ADDENDUM 03, DELTA 03 DATE 05.01.2026

PROJECT: Santa Rosa Freestanding Emergency Room

ARCHITECT'S PROJECT NUMBER:
225014.00

OWNER: HCA Florida Fort Walton-Destin Hospital

1 FLOOR PLAN - ACCESS CONTROL
SCALE: 1/8" = 1'-0"

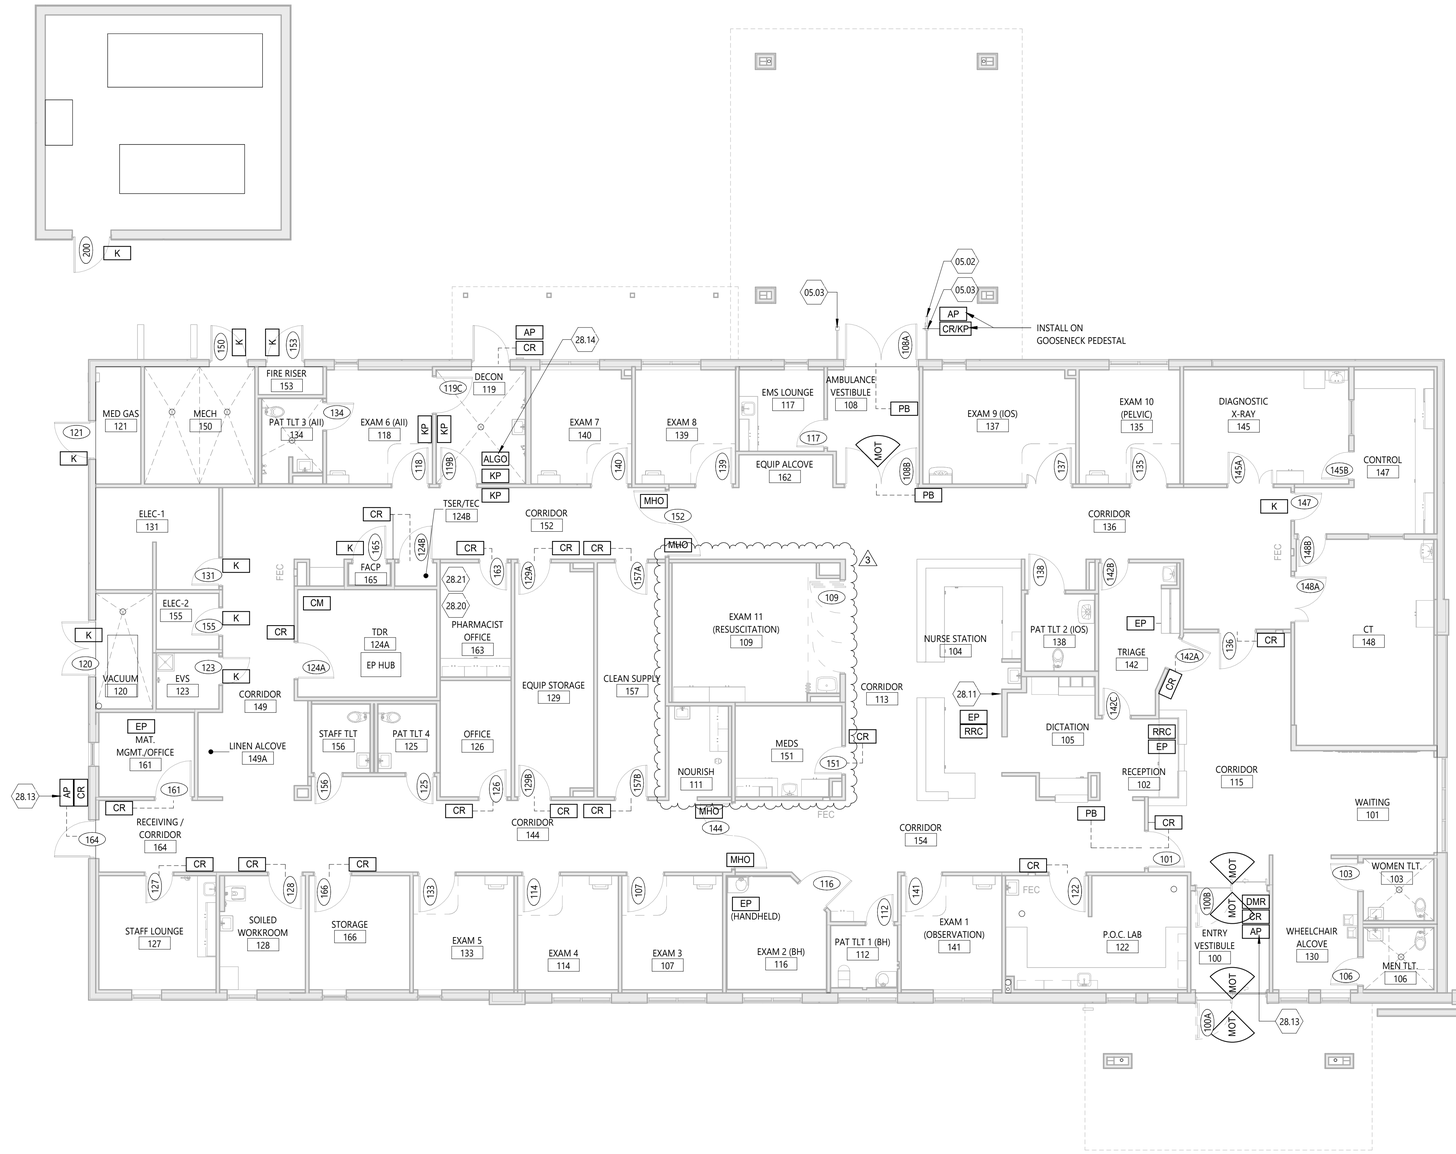
1. Reference Detail 1: "Floor Plan – Access Control:"
    a. Revised the Trauma Room, Meds Room, and Nourishment Alcove core per client direction; associated access control tags revised as necessary.

1 REFLECTED CEILING PLAN
SCALE: 1/4" = 1'-0"

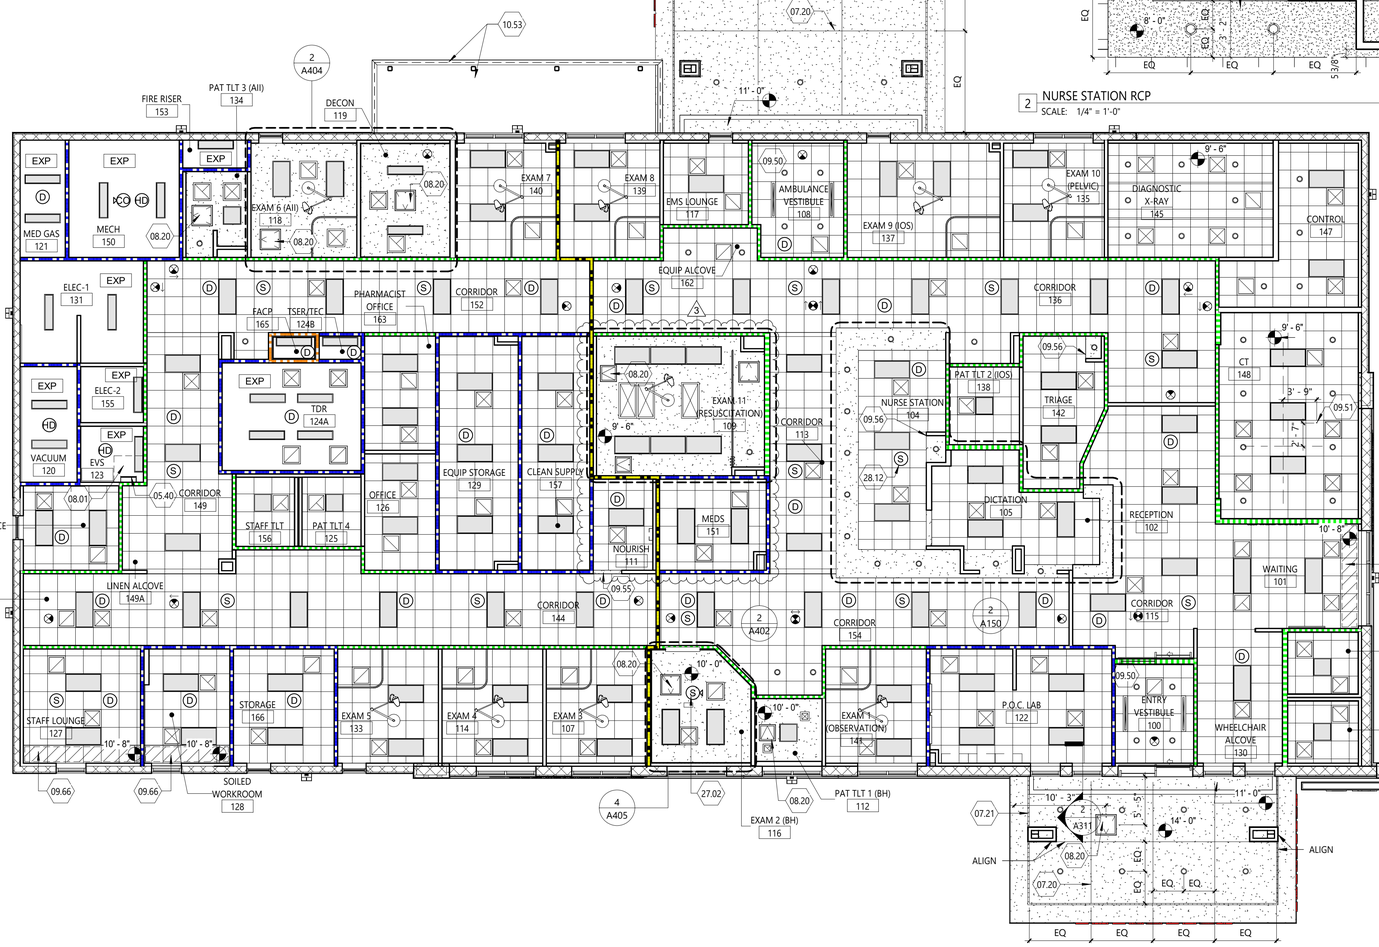
1. Reference Detail 1: "Reflected Ceiling Plan:"
    a. Revised the Trauma Room, Meds Room, and Nourishment Alcove core per client direction.

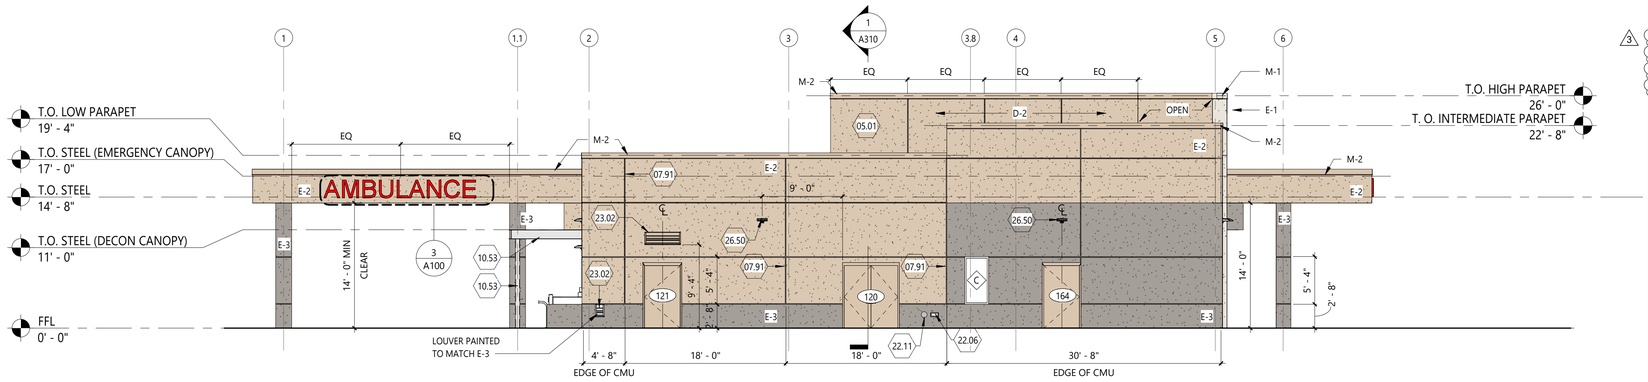
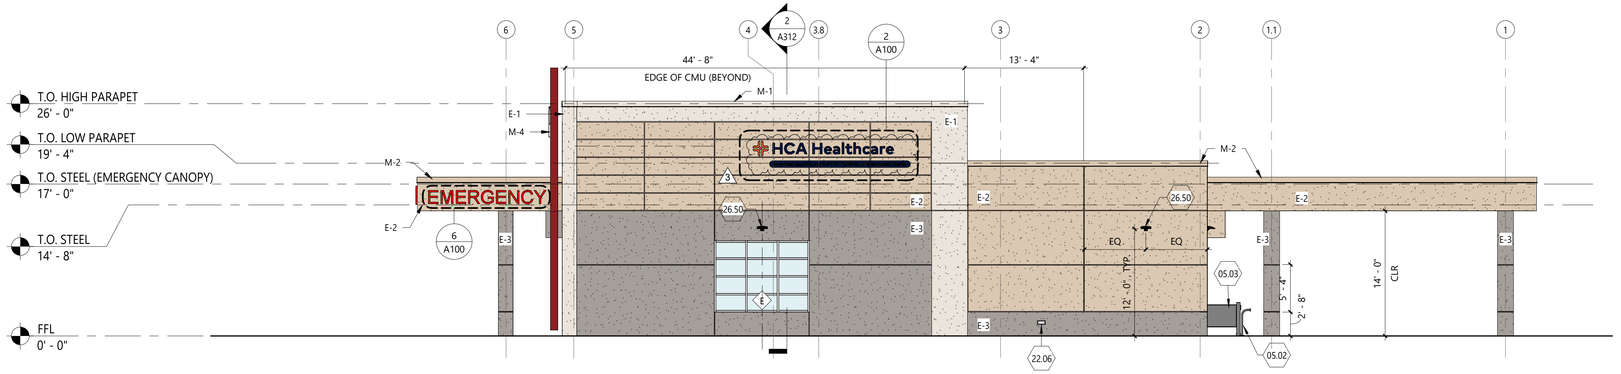
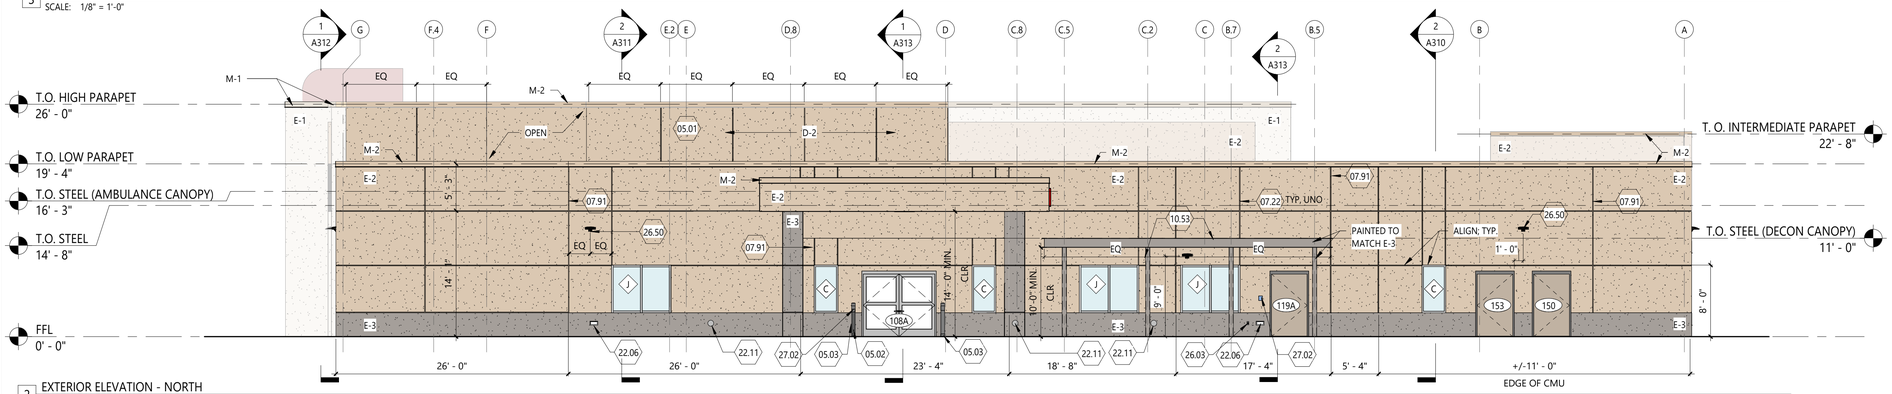
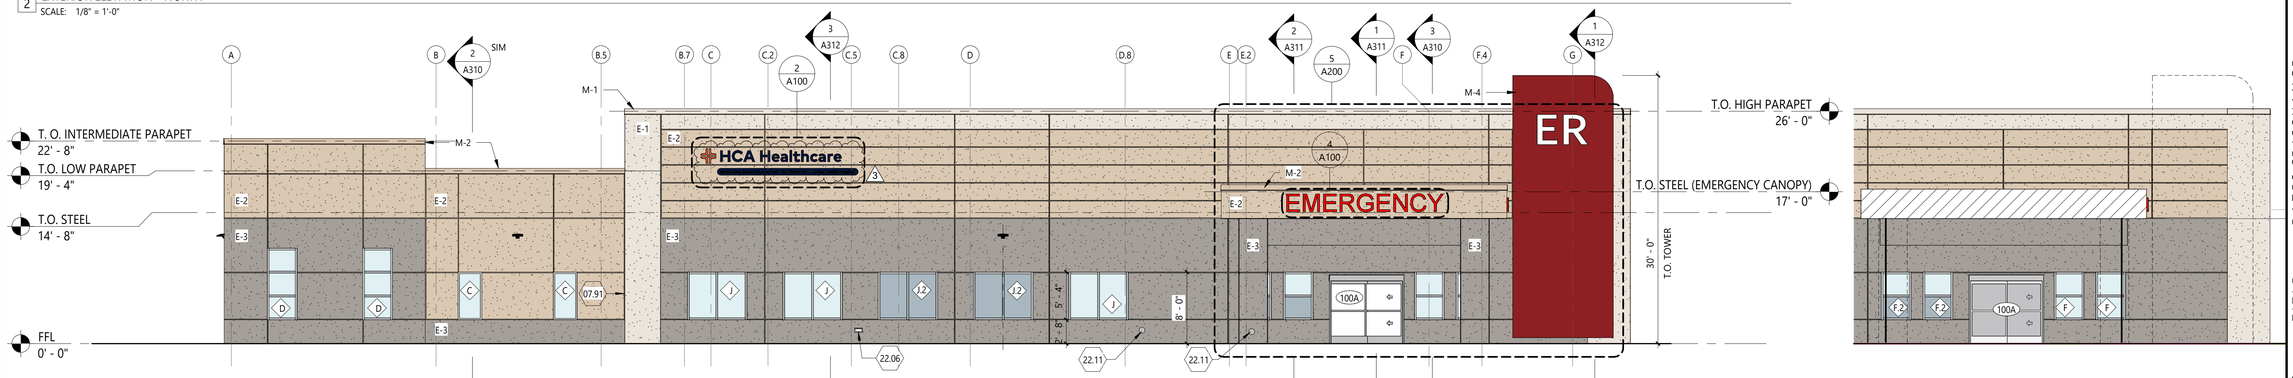
1. Reference "Elevation Legend:"
    a. Color for Material E-1 changed to Munsell 10YR 9.00/0.5 per Walton County review comment.
    b. Color for Material M-1 changed to Munsell 10YR 9.00/0.5 per Walton County review comment.
    c. Language for Material M-4 note revised to change "…color to match…" to "…color to be…" per Walton County review comment.
2. Reference Detail 1: "Exterior Elevation – South:"
    a. Revised the exterior building signage detail to change the facility name from "Emergency" to "ER" per client direction.
3. Reference Detail 3 – "Exterior Elevation – East:"
    a. Revised the exterior building signage detail to change the facility name from "Emergency" to "ER" per client direction.

2 WALL SECTION
SCALE: 3/4" = 1'-0"

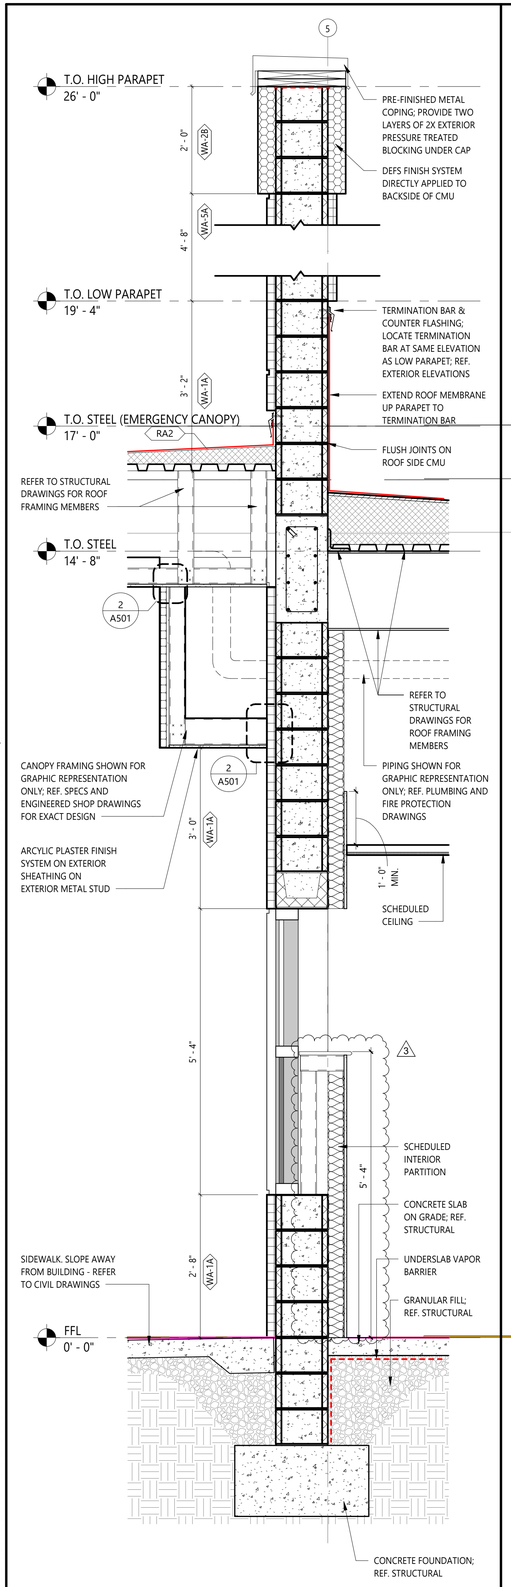
1. Reference Detail 2: "Wall Section:"
    a. Revised wall detail for additional clarification.

1D TYPICAL EXAM - HEADWALL
SCALE: 1/2" = 1'-0"

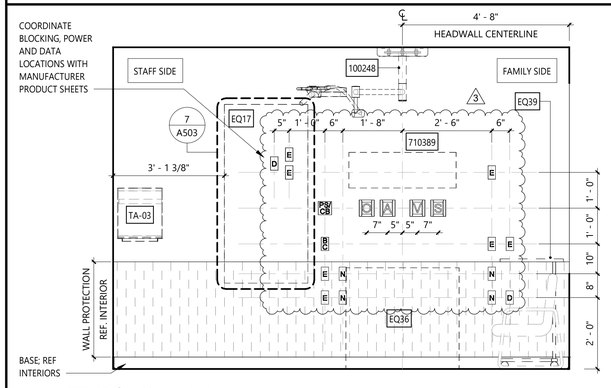
1. Reference Detail 1D: "Typical Exam – Headwall:"
    a. Changed detail name from "side wall" to "headwall" for additional clarification.
    b. Typical exam room headwall updated to the latest client design.
2. Reference Detail 2A: "Pelvic Exam – Headwall:"

1A TRAUMA - HEADWALL
SCALE: 1/2" = 1'-0"

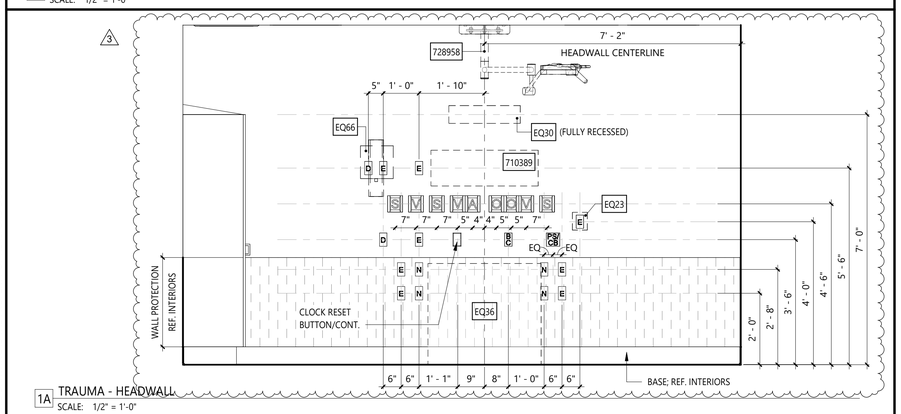
1. Reference Detail 1: "Exam 11 (Resuscitation) – Enlarged Plan:"
    a. Revised the Trauma Room, Meds Room, and Nourishment Alcove per client direction; enlarged plan updated as necessary.
2. Reference Detail 1A: "Trauma – Headwall:"
    a. Trauma room headwall updated to the latest client design.
3. Reference Detail 2: "Exam 11 (Trauma) – Enlarged RCP:"
    a. Revised headwall centerline dimension to match updated headwall elevation.

1B AII EXAM - HEADWALL
SCALE: 1/2" = 1'-0"

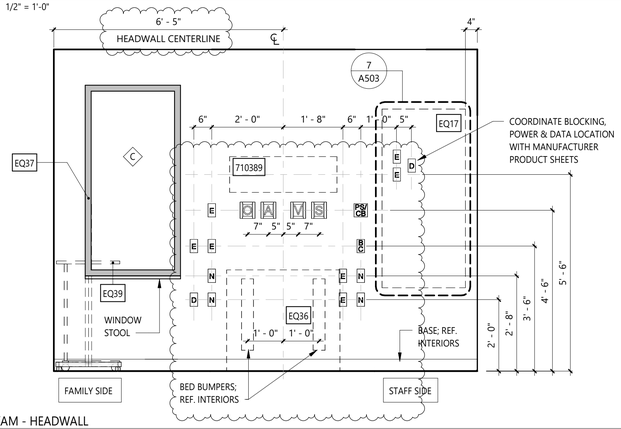
1. Reference Detail 1: "Isolation Exam – Enlarged Plan:"
    a. Revised headwall centerline dimension to match updated headwall elevation.
2. Reference Detail 1B: " A.I.I. Exam – Headwall:"
    a. Isolation exam room headwall updated to latest client design.
    b. Revised headwall centerline dimension to match updated headwall elevation.
3. Reference Detail 2: "Isolation Exam – Reflected Ceiling Plan:"
    a. Revised headwall centerline dimension to match updated headwall elevation.
    b. Centered exhaust grille along the new headwall centerline.

4 BEHAVIORAL EXAM - ENLARGED REFLECTED CEILING PLAN
SCALE: 1/2" = 1'-0"

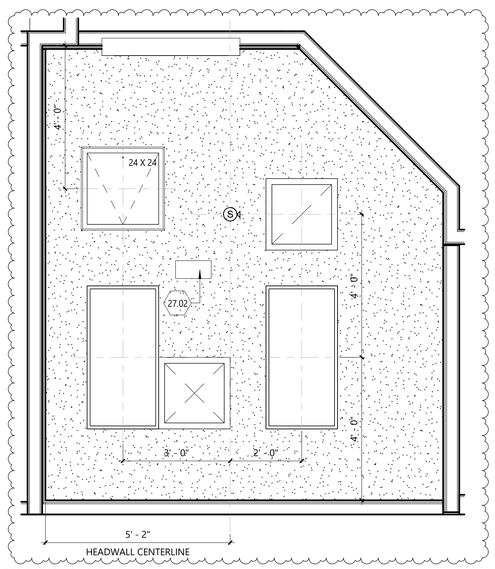
b. Note for the coordination of the power and data to the recessed TV enclosure added for clarification.
3. Reference Detail 4: "Behavioral Exam – Enlarged Reflected Ceiling Plan:"
   a. Revised dimensions of the 2'x4' lights for clarification.

3 BEHAVIORALEXAM - FOOTWALL
SCALE: 1/2" = 1'-0"

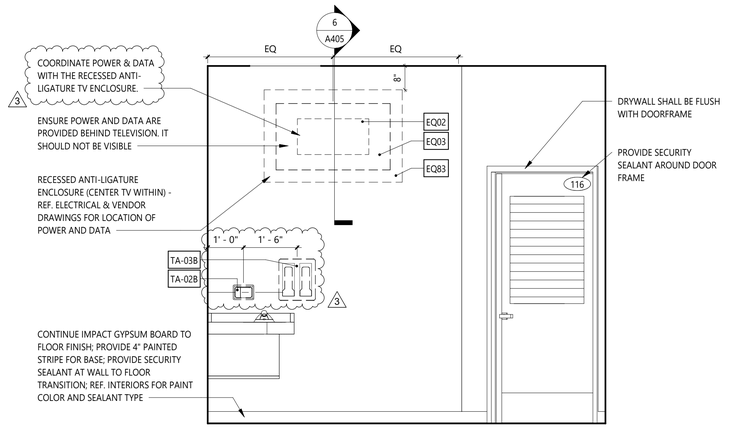
1. Reference Detail 1: "Behavioral Exam – Enlarged Plan:"
    a. Added headwall centerline dimension for additional clarification.
    b. Added partition tag for additional clarification.
2. Reference Detail 3: "Behavioral Exam – Footwall:"
    a. Added dimensions to locate the recessed soap dispenser and anti-ligature paper towel dispenser.

1 CASEWORK SECTIONS 1
SCALE: 1 1/2" = 1'-0"

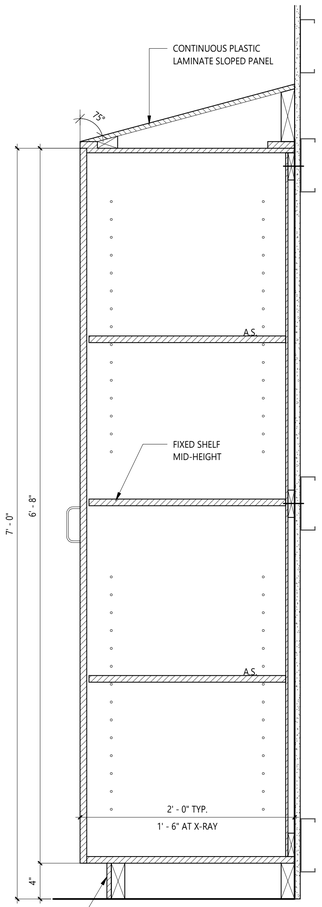
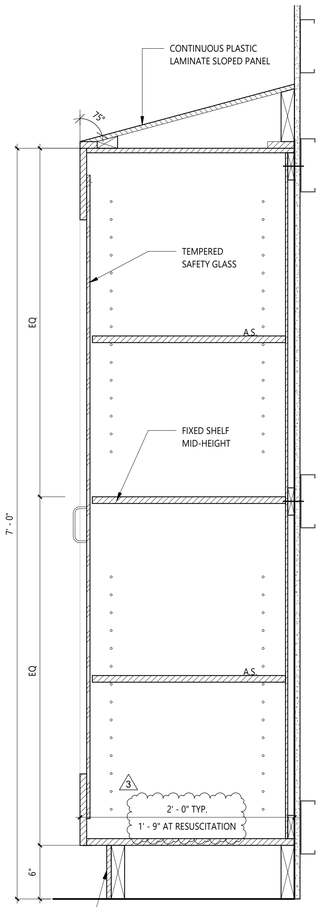
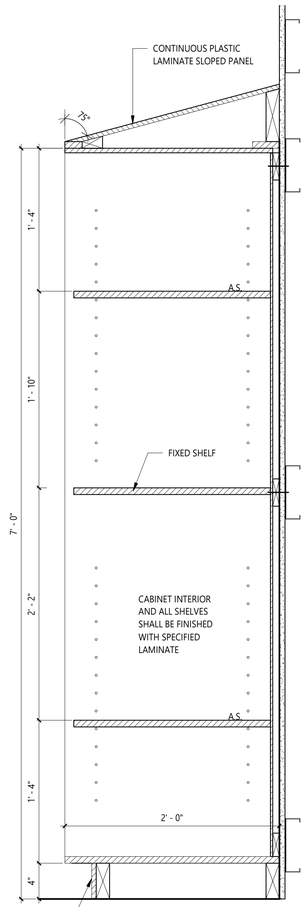
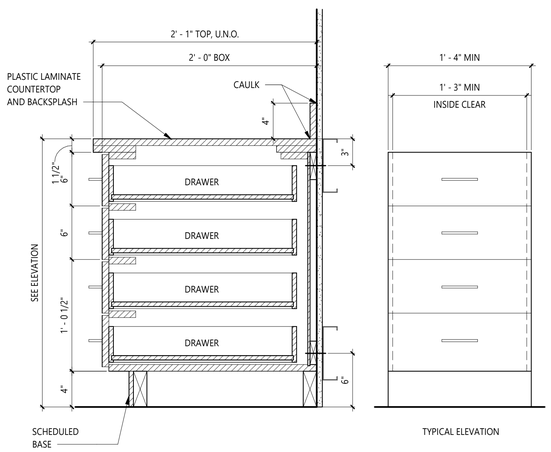
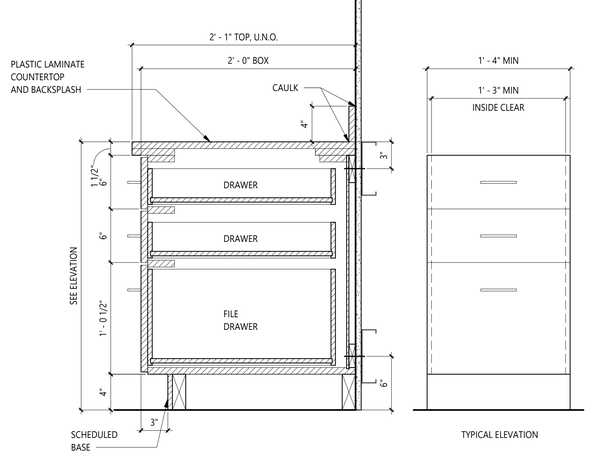
Sheet A710 – CASEWORK SECTIONS AND DETAILS:
1. Reference Detail 1: "Casework Sections 1:"
   a. Dimension note for 1'-9" at Resuscitation added for clarification; cabinet depth reduced to maintain required bed clearances.

1 FURNITURE PLAN
1/8" = 1'-0"

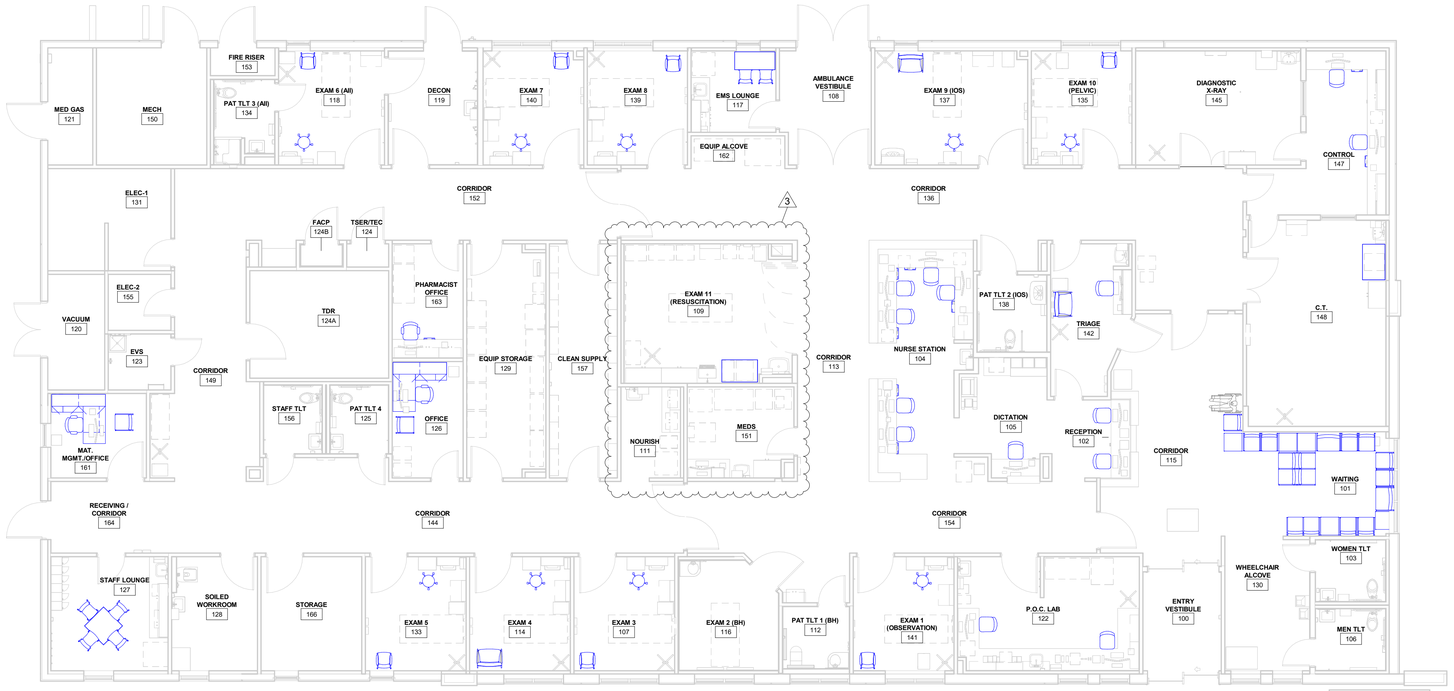
Sheet Number: F1.4 – FURNITURE PLAN
- Furniture location changed due to mirroring of room locations for Trauma/Meds/Nourish, finishes remained the same.
